PRELIMINARY OVERALL
AREA DEVELOPMENT PLAN
CRYSTAL HILL SUBDIVISION

INFORMATION SHEET FOR
PRELIMINARY OVERALL AREA DEVELOPMENT PLAN
(P.O.A.D.P.)

Re: Crystal Hill Preliminary Plan
 P.O.A.D.P.
File #: 84-12-59-08 Revised plan on June 25, 1985

Re: Crystal Hill Preliminary Plan
 P.O.A.D.P.
File #: 84-12-59-08

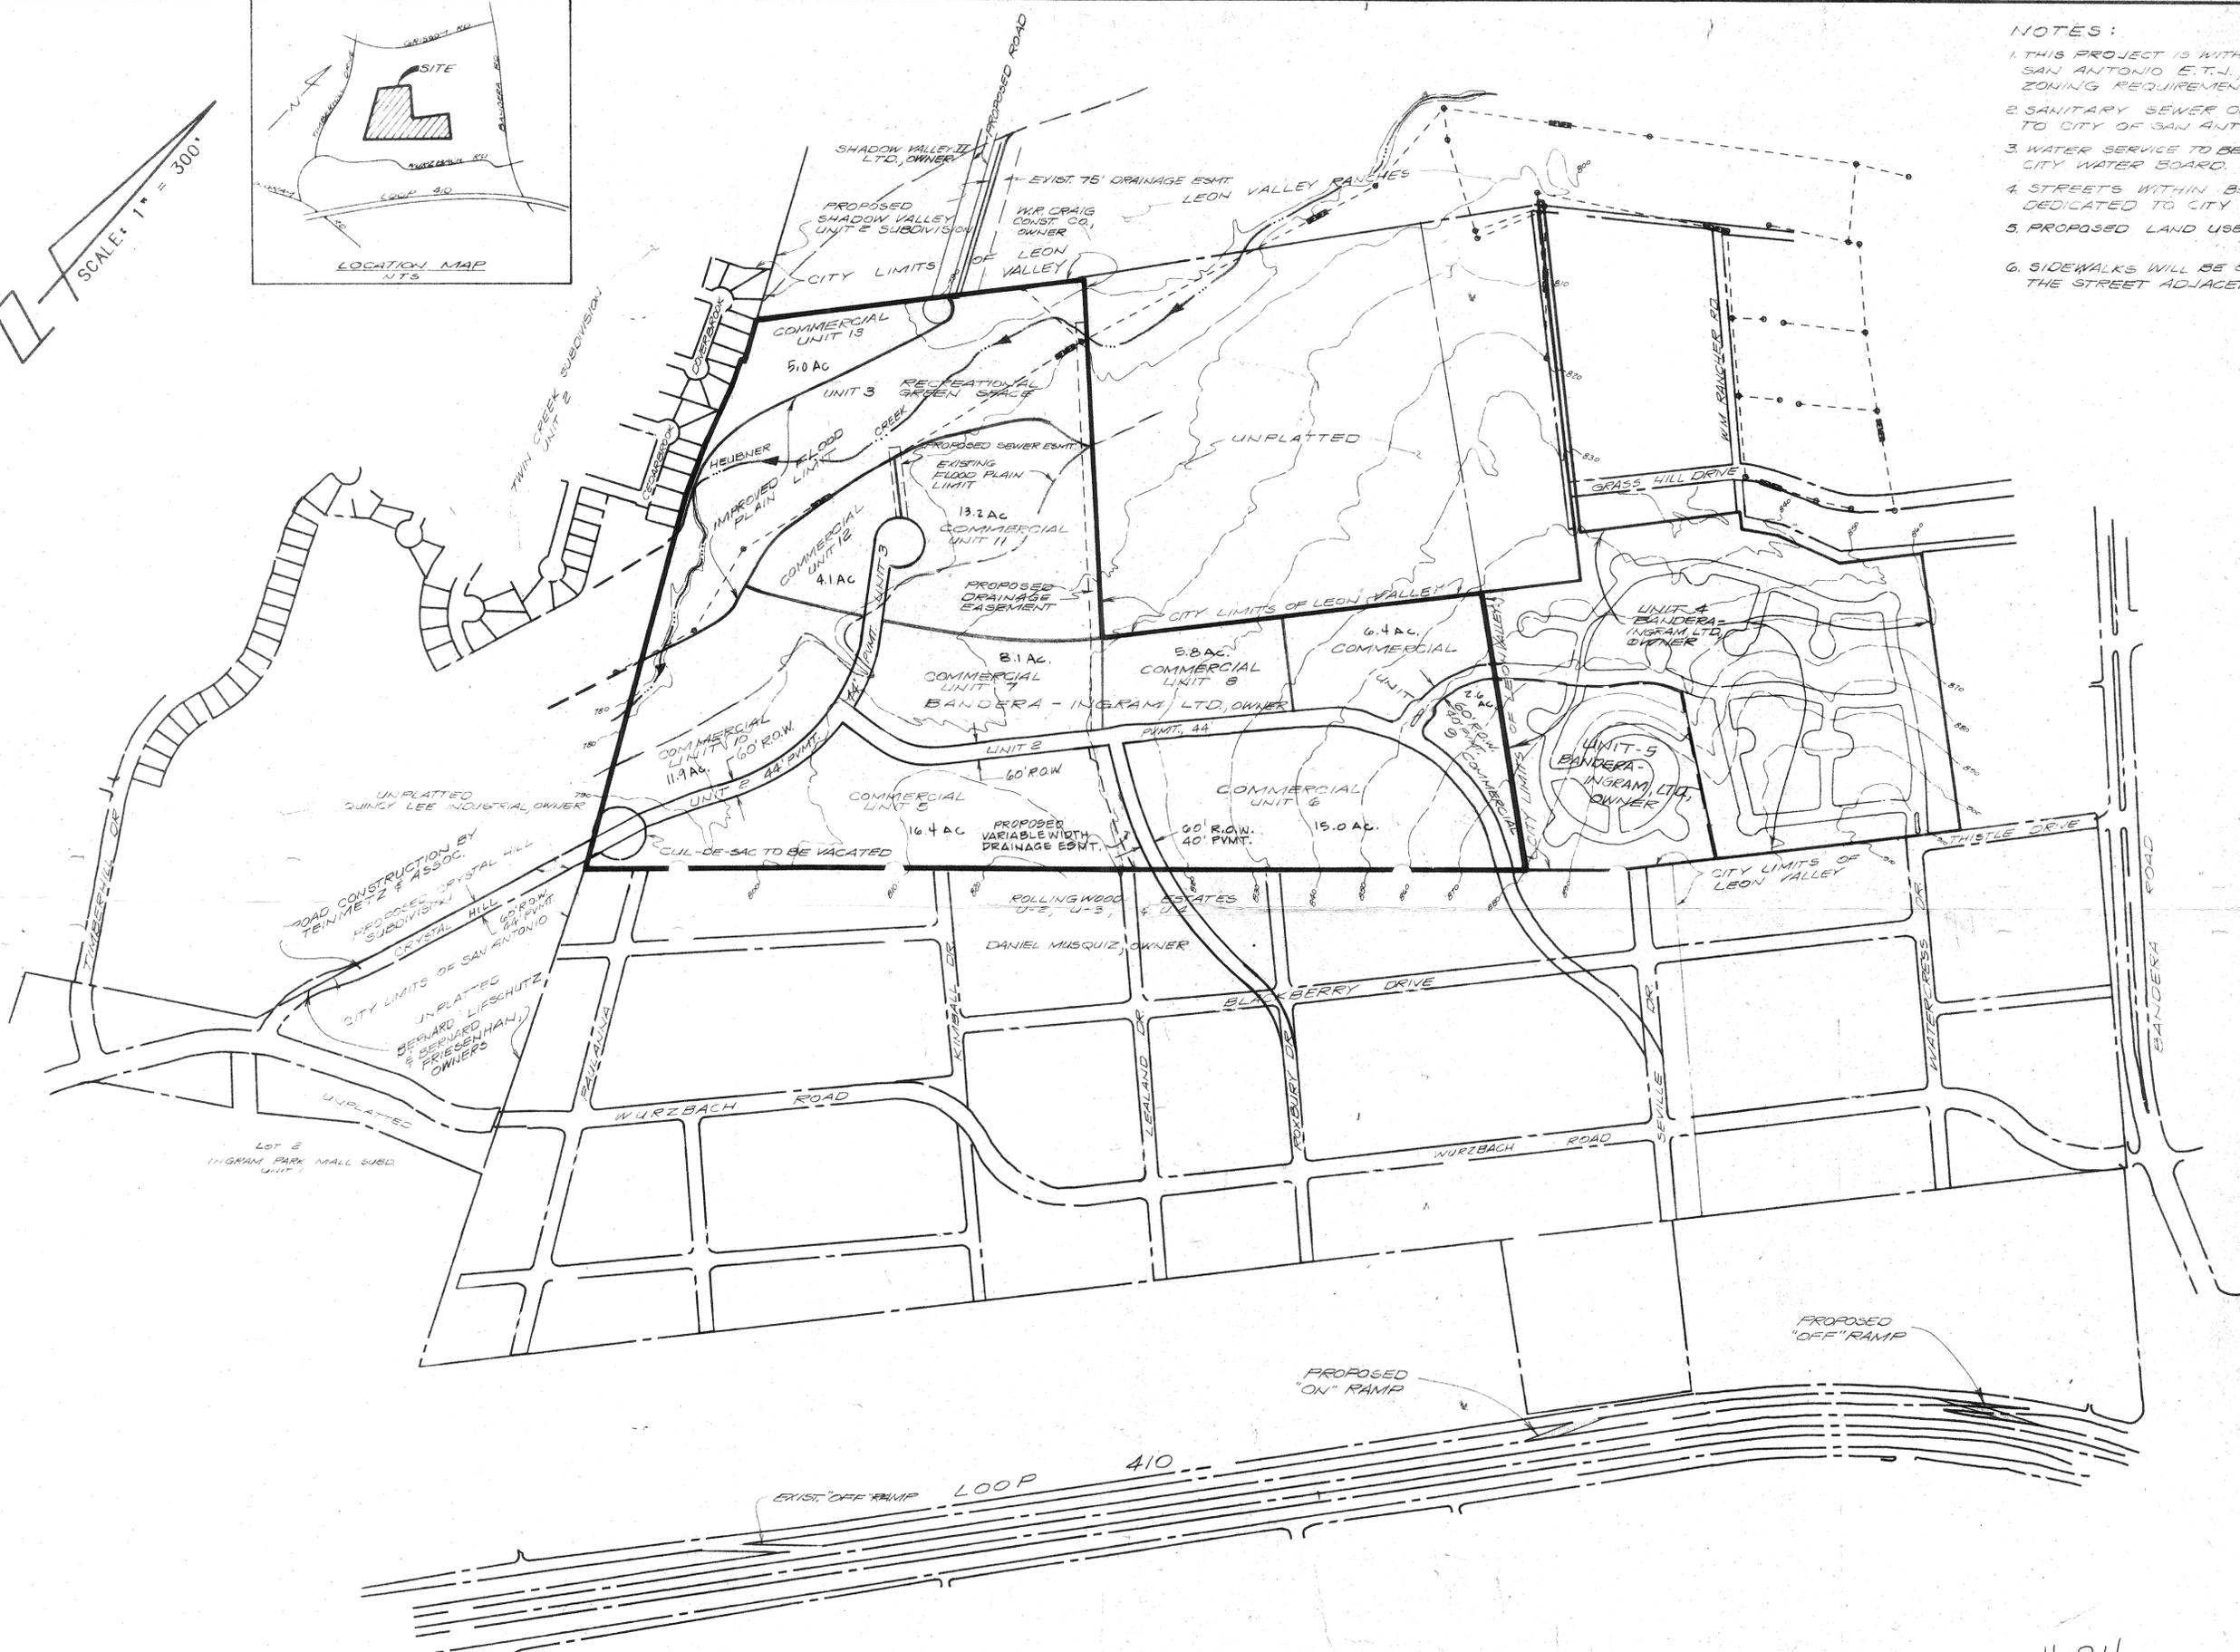
6-25-84	REVISED PROPOSED LAND USE TO (N) DESIGN COMMERCIAL FOR THE WHOLE OF THE UNIT 13 (NO DESIGN CHANGES)	AAA
9-6-84	SHOWED DRAIN ESMT. IN CORRECT PLACE	A.S.M.
7-21-84	ALIGNED UNIT STREETS TO MATCH SOMERVILLE ENGO	AAA
3-19-84	ADD UNIT ACERAGES	B.E.
2/21/84		
DATE	DESCRIPTION	APPROVED
	REVISIONS	FILE LOCATION

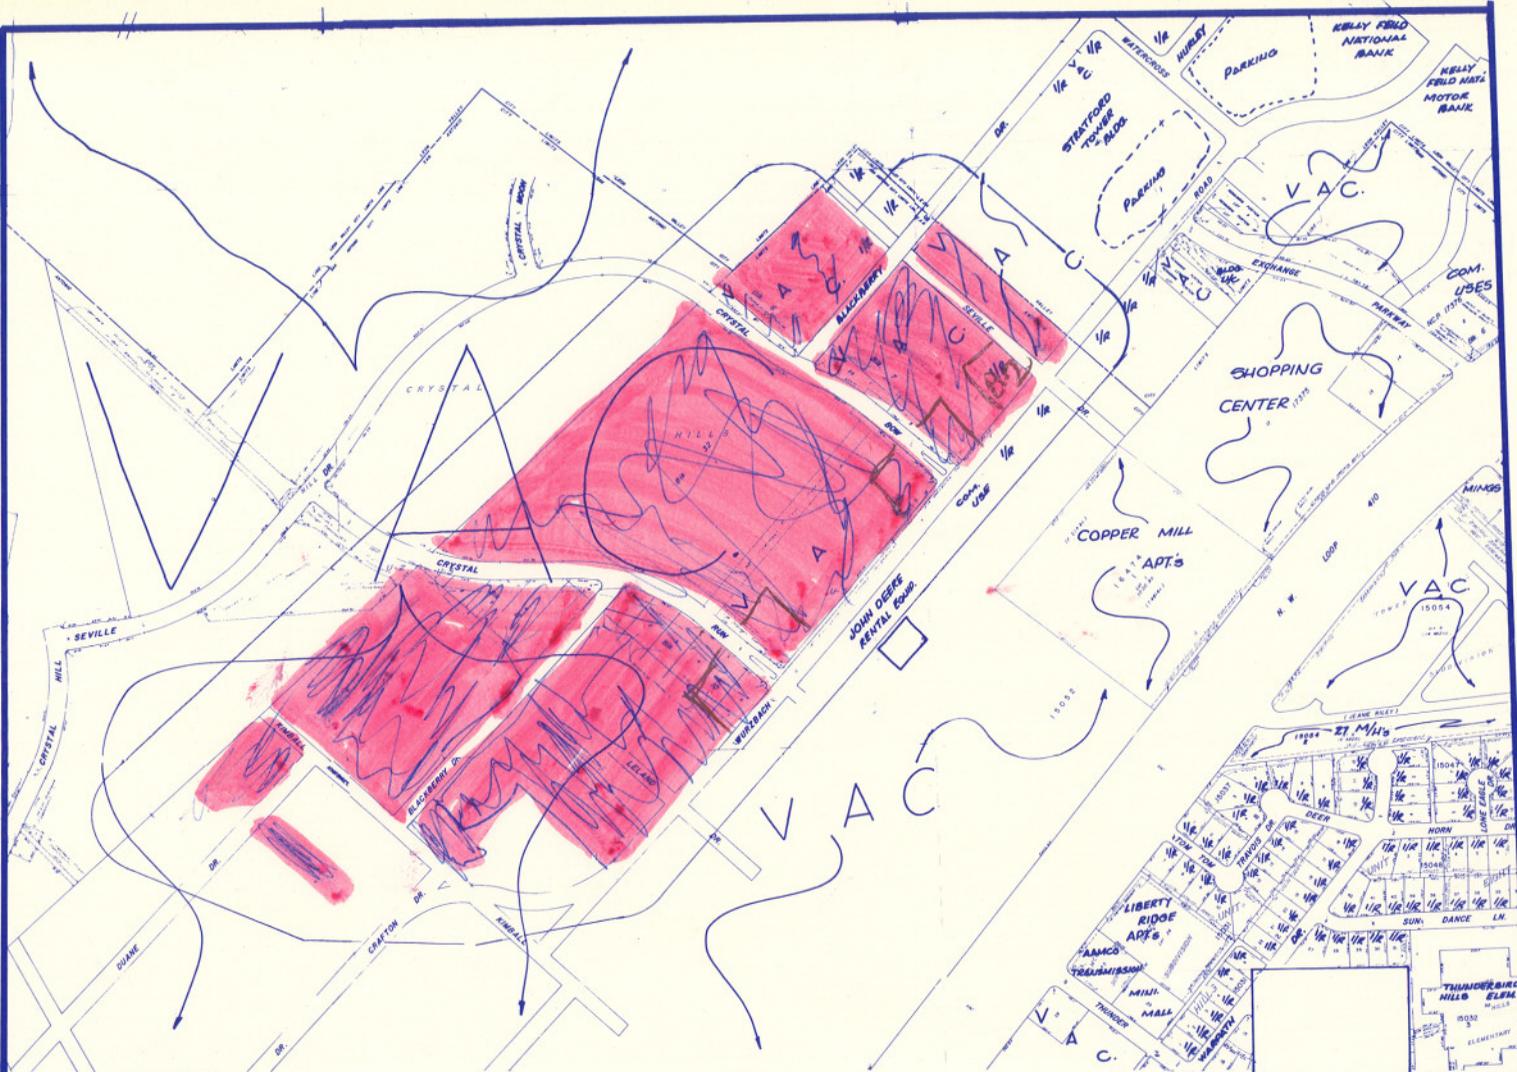
It is noted that in the review of the Rollingwood Ridge P.O.A.D.P. (File #84-12-55-28) the subdivider's (Dan Musquiz) representing engineer, Ron Somerville, was given three recommended street design alternatives. The alternatives were to provide a street network that interconnects the two planned developments to Loop 410. Because of the alternatives, it was also recommended that Mr. Somerville coordinate planning efforts with adjacent property owners to the north and south of Rollingwood Ridge development.

This was to avoid any planned street design discrepancies. In view of this, we also suggest that you work with Mr. Somerville to facilitate planning in the area. See the attached P.O.A.D.P. for the three street design alternatives. The alignments are identified as A,B, & C.
